A New Fire Station for
Harmonville Fire Company – Plymouth Valley Station

DOCUMENT 00 9001 - ADDENDUM NUMBER 2 – 3/28/25

A2.01

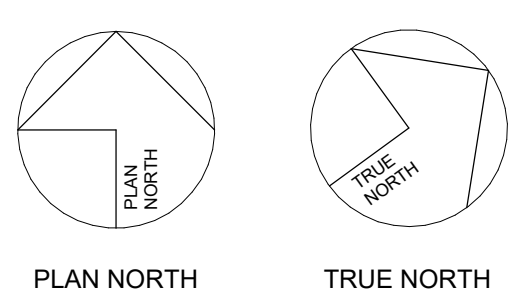
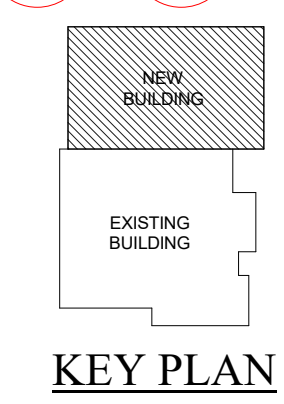
- 9001.08 Drawing sheet A2.01 note that “BB” designations have been added to the plan to indicate where CMU block should have bullnosed corners.
- 9001.09 Drawing sheet A2.01 note that the MB 8’ has been removed from Conference 200, and General Note #7 is to be removed. There are no Marker Boards as part of this project.

- 9001.10 Drawing sheet A2.01 note that the CMU wall thickness has been adjusted.
- 9001.11 Drawing sheet A2.02 note that at the northwest corner preparation for a second future Plymovent motor have been removed, so no roof curbs or penetrations are required in this location.

8 WALL SECTION 8
A3.04 1/2" = 1'-0"

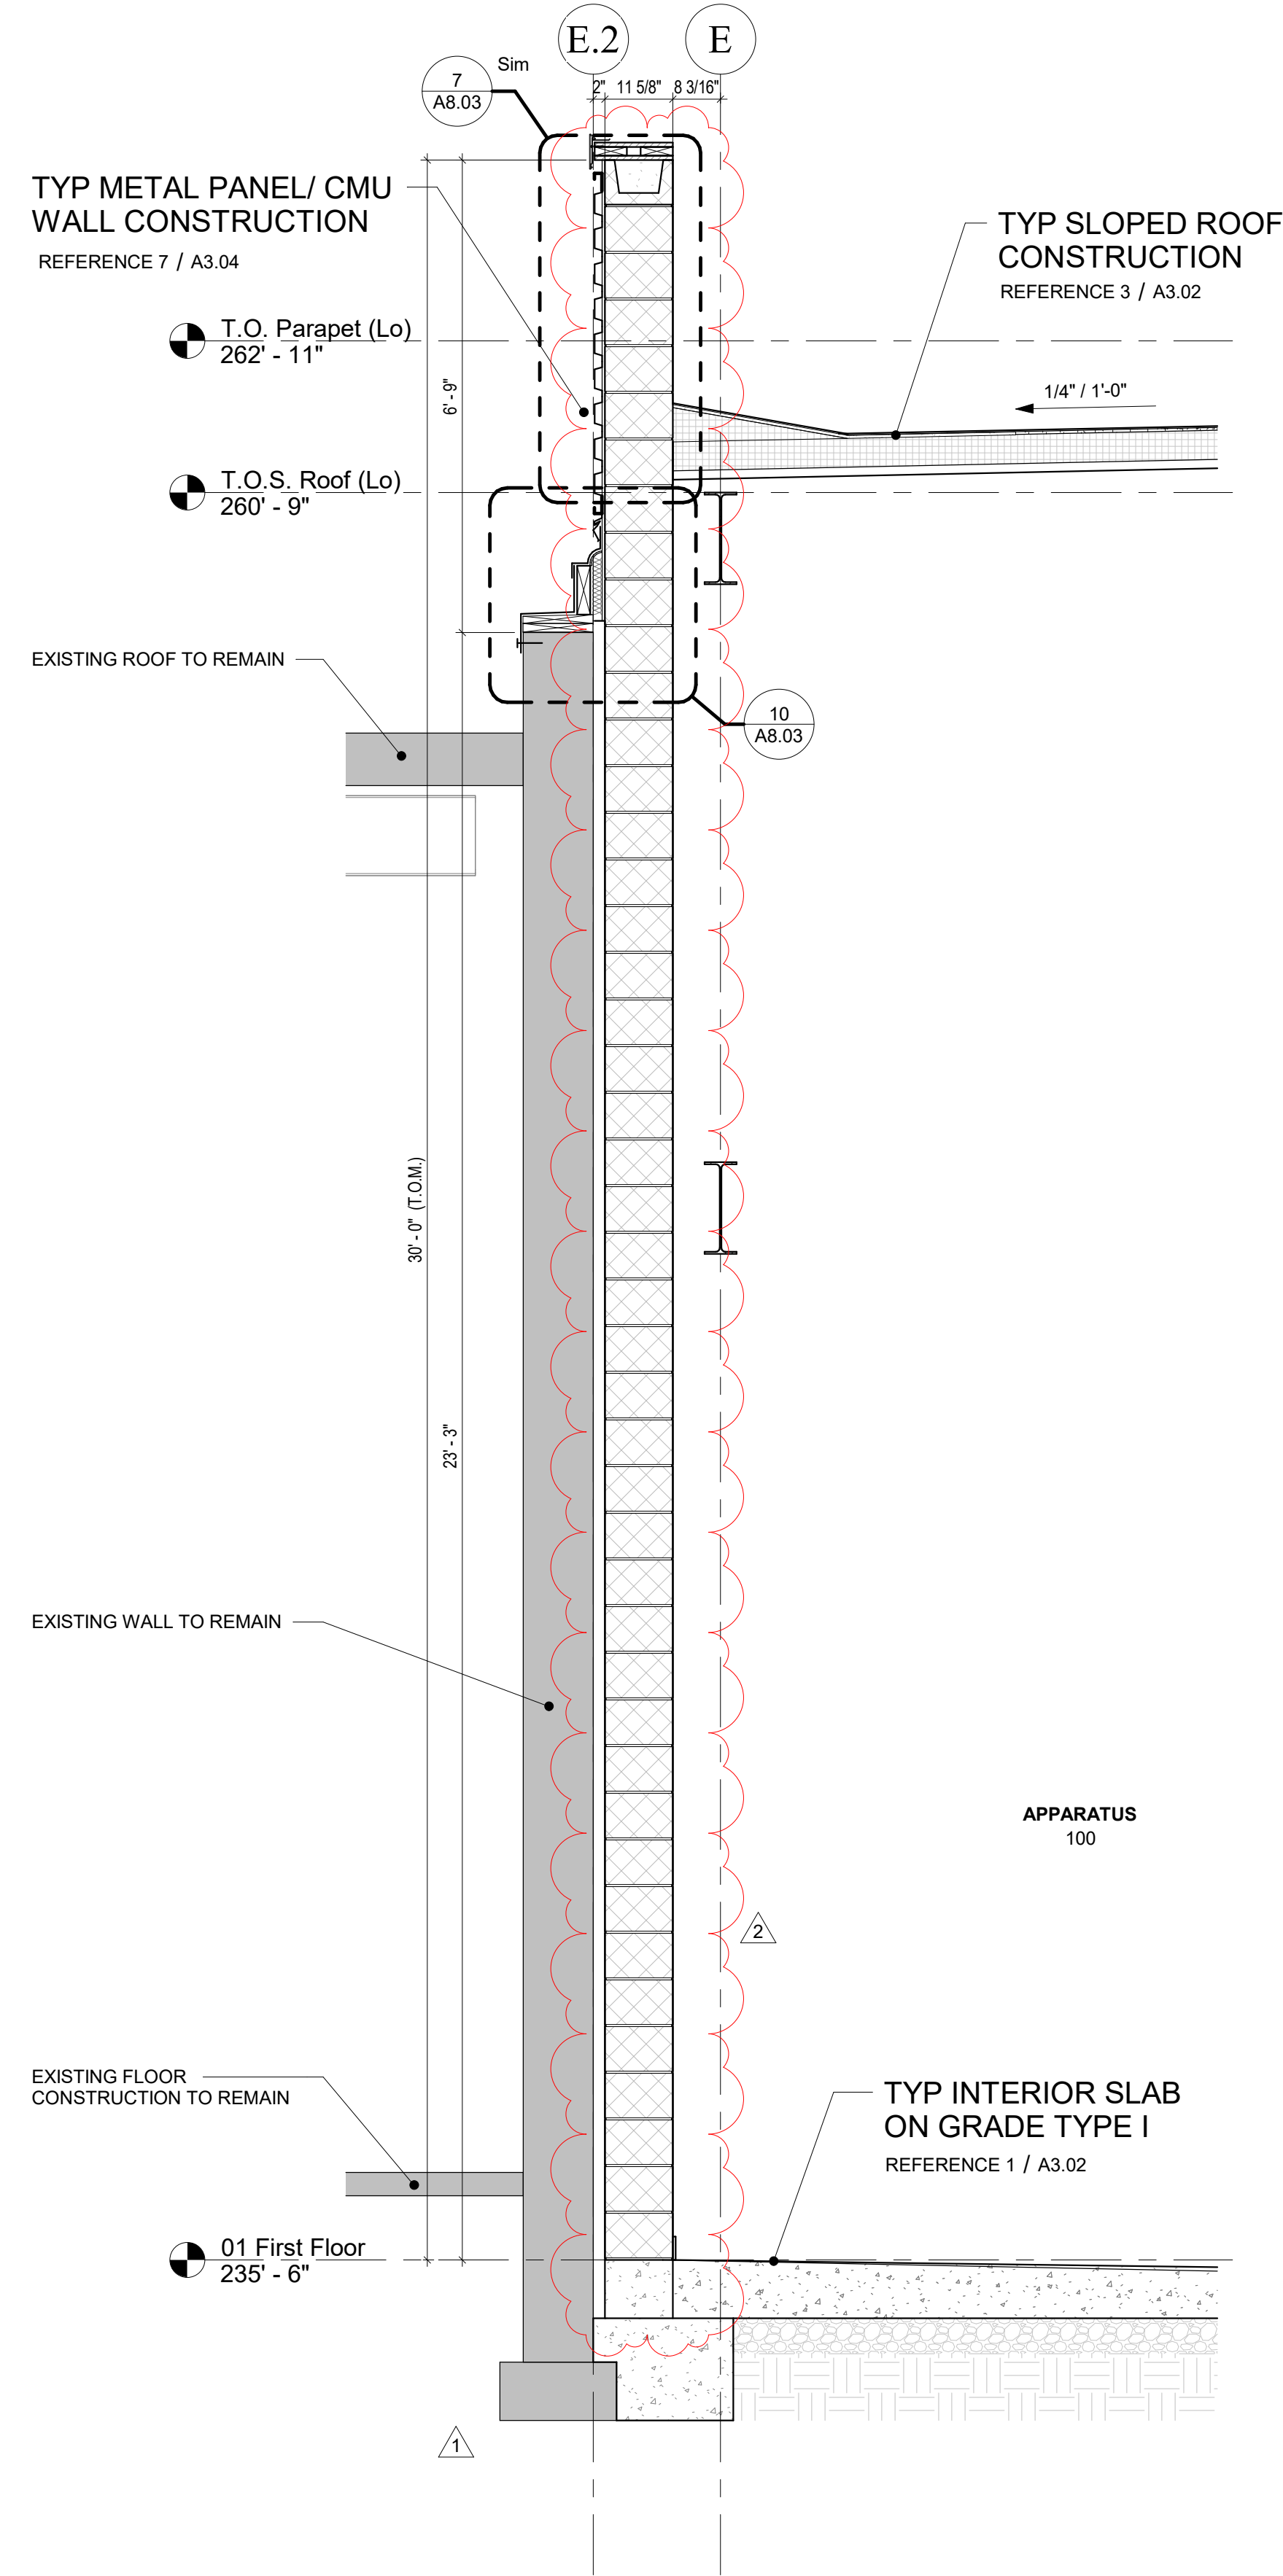
- 9001.12 Drawing sheet A3.04 Section Detail 8 the CMU thickness has been changed.
- 9001.13 Drawing sheet A3.05 Section Detail 9 the CMU thickness has been changed.

10 WALL SECTION 10
A3.05 1/2" = 1'-0"

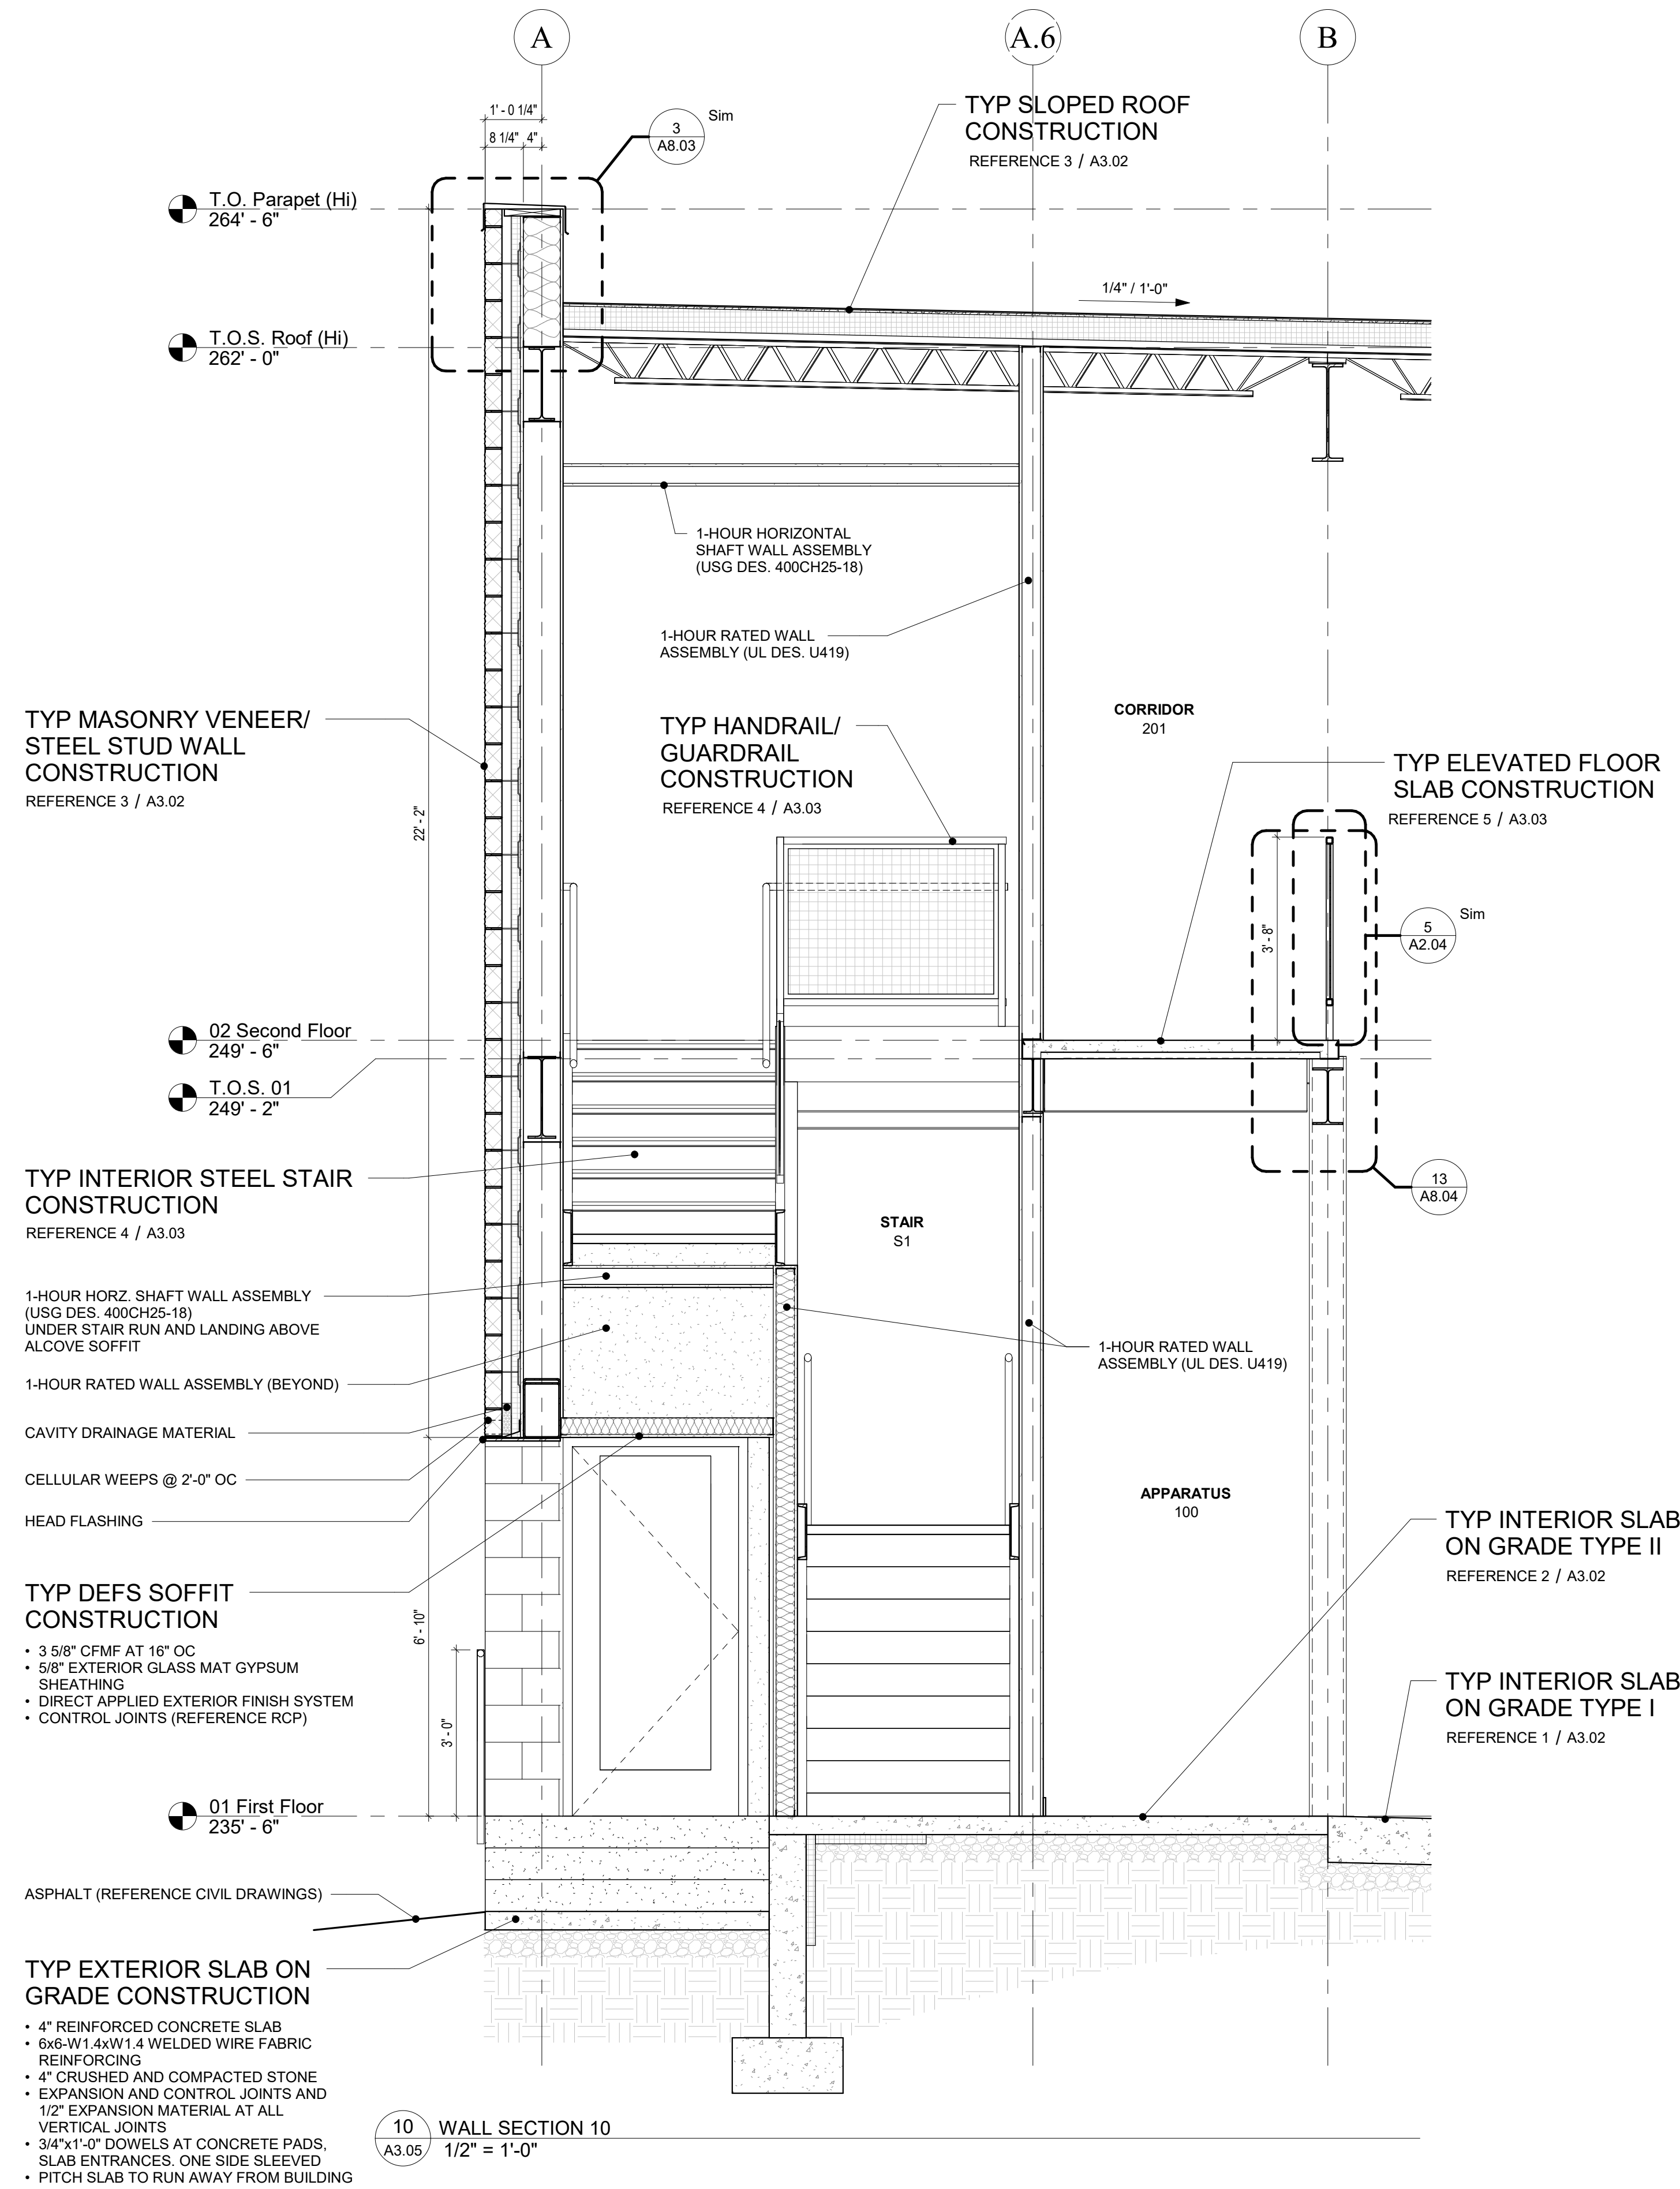
- 9001.16 Drawing sheet A8.03 Detail 10 and 11 have been updated to reflect the change of the cmu thickness and placement.
- 9001.17 Drawing Sheet S0.01 has been updated to provide a note on the specifics of the microsynthetic fibers that is to be added to the concrete.

D
A8.01
PLAN DETAIL
1 1/2" = 1'-0"

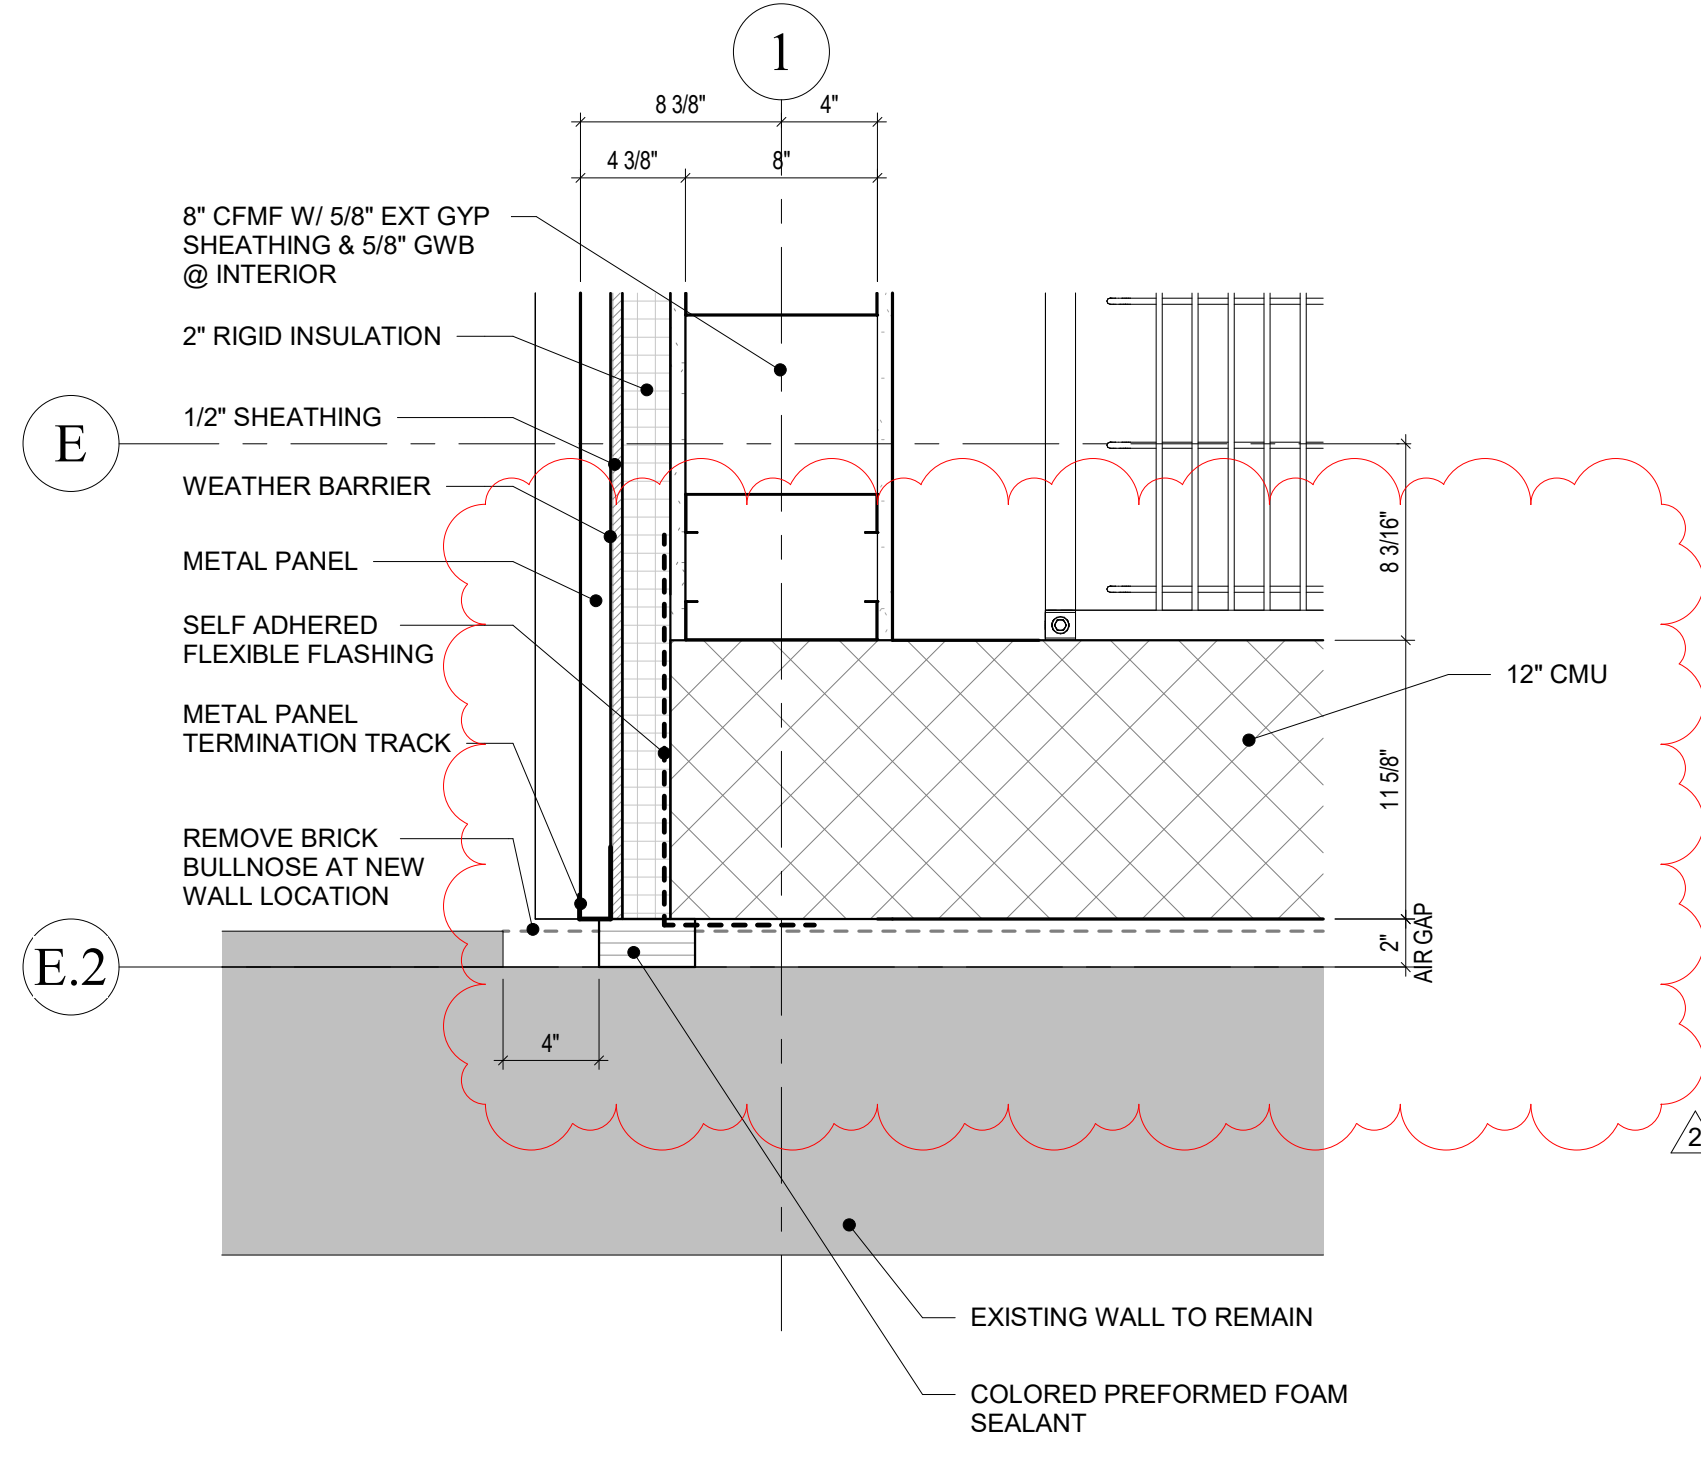
- 9001.14 Drawing sheet A8.01 Detail D and E have been updated to reflect the change of cmu thickness and placement.
- 9001.15 Drawing sheet A8.02 Detail J has been updated to reflect the change of the cmu thickness and placement.
